HISTORIC AND DESIGN REVIEW COMMISSION

June 19, 2019

HDRC CASE NO: 2019-352
ADDRESS: 1021 N PALMETTO
LEGAL DESCRIPTION: NCB 1369 BLK 6 LOT N 46 FT OF 8 & 9 ARB A-1
ZONING: R-4,H
CITY COUNCIL DIST.: 2
DISTRICT: Dignowity Hill Historic District
APPLICANT: James Benfield/BENFILED REAL ESTATE LLC & G6 HOMES LLC
OWNER: James Benfield/BENFILED REAL ESTATE LLC & G6 HOMES LLC
TYPE OF WORK: Amendment to previously approved siding specifications
APPLICATION RECEIVED: May 16, 2019
60-DAY REVIEW: July 15, 2019
CASE MANAGER: Stephanie Phillips
REQUEST:

The applicant is requesting a Certificate of Appropriateness for an amendment to allow for the use of faux wood Hardie siding in lieu of the previously approved smooth Hardie siding on the new construction located at 1021 N Palmetto.

Photographs

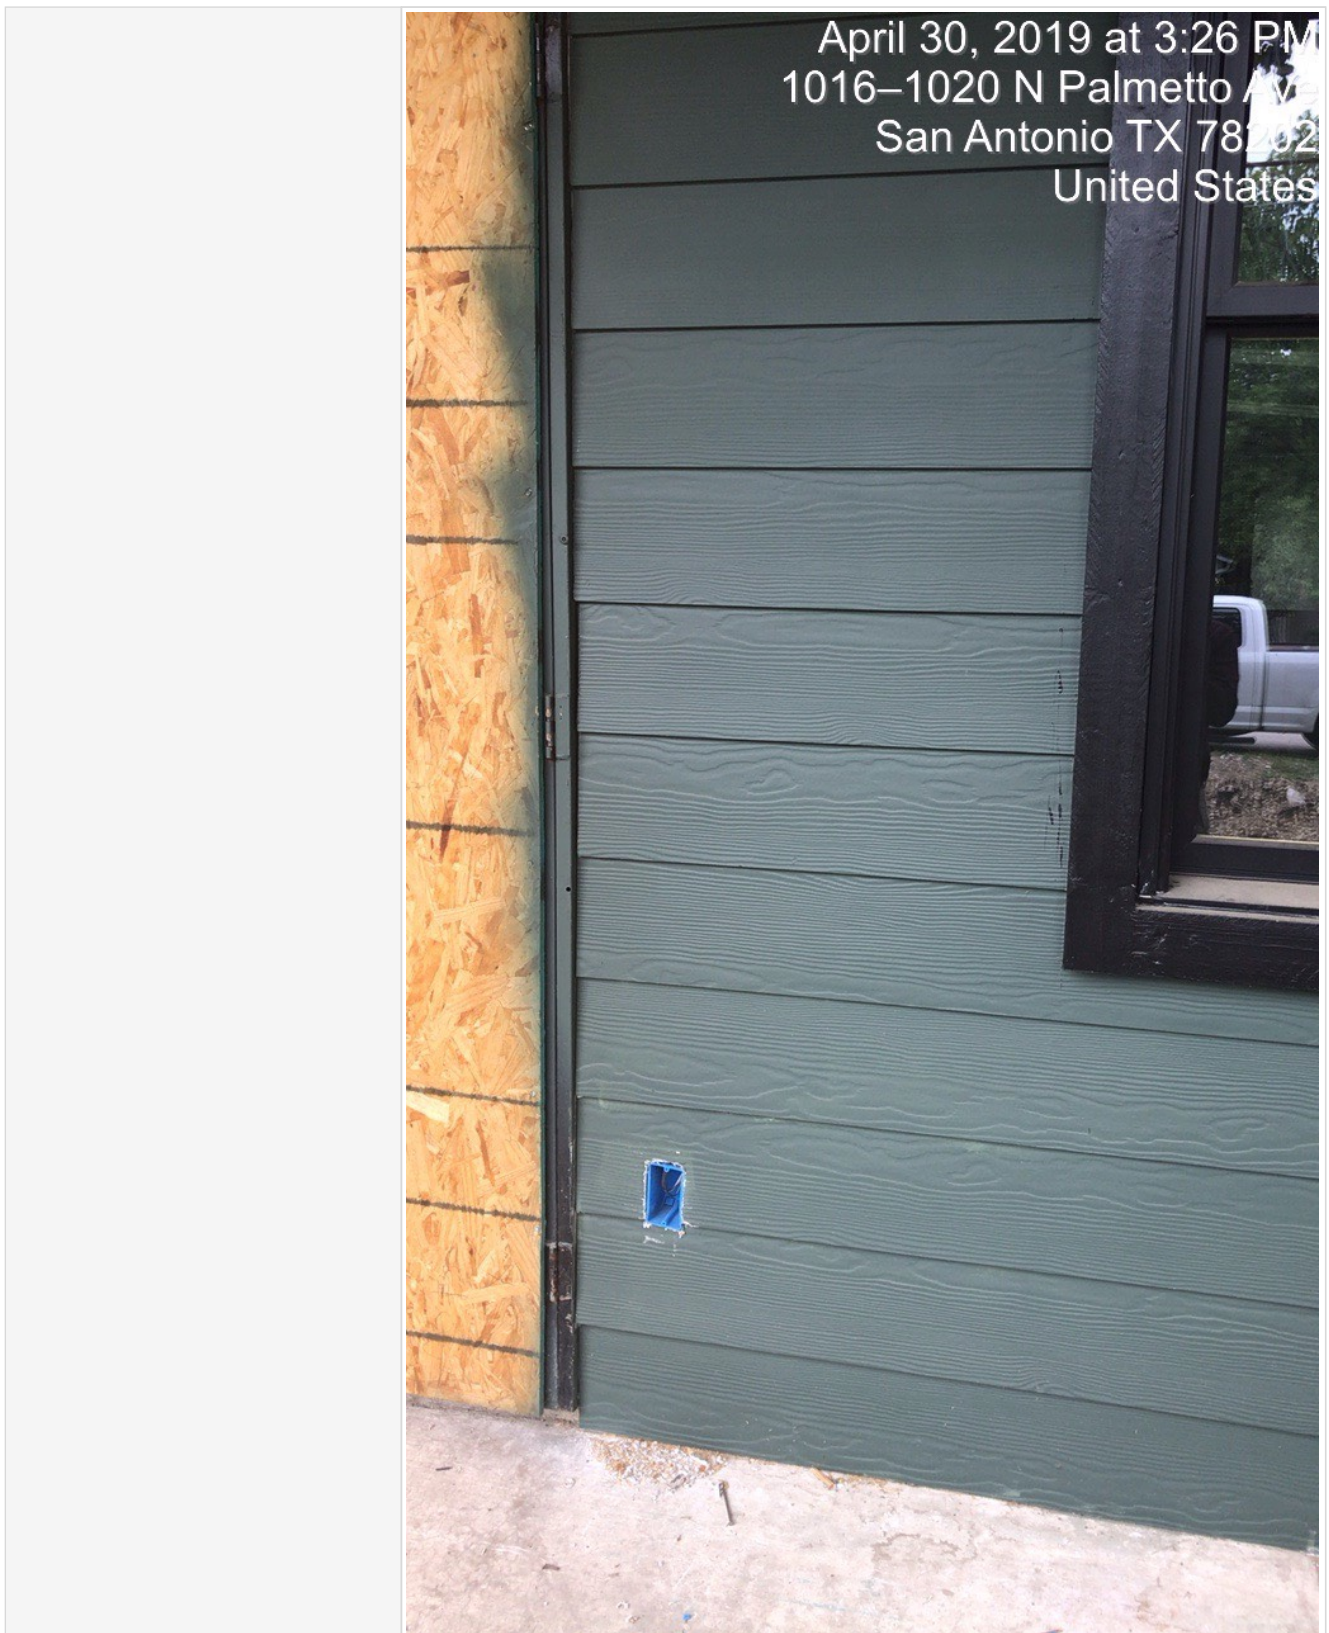
On April 30, 2019, a Notice of Investigation was posted on the property by OHP staff due to the use of faux grain Hardie siding, which was inconsistent with the final approval for new construction granted by the HDRC on March 21, 2018. Photographs from the site investigation are included in the exhibits.

Date	04/30/2019
Time	03:39 PM (-5 GMT)
Context	citizen report
Present Staff	Huy Pham, Edward Hall
Present Individuals	None
Types of Work Observed	New Construction
Amount of Work Completed	50%
Description of work	Installation of siding material inconsistent with approval.
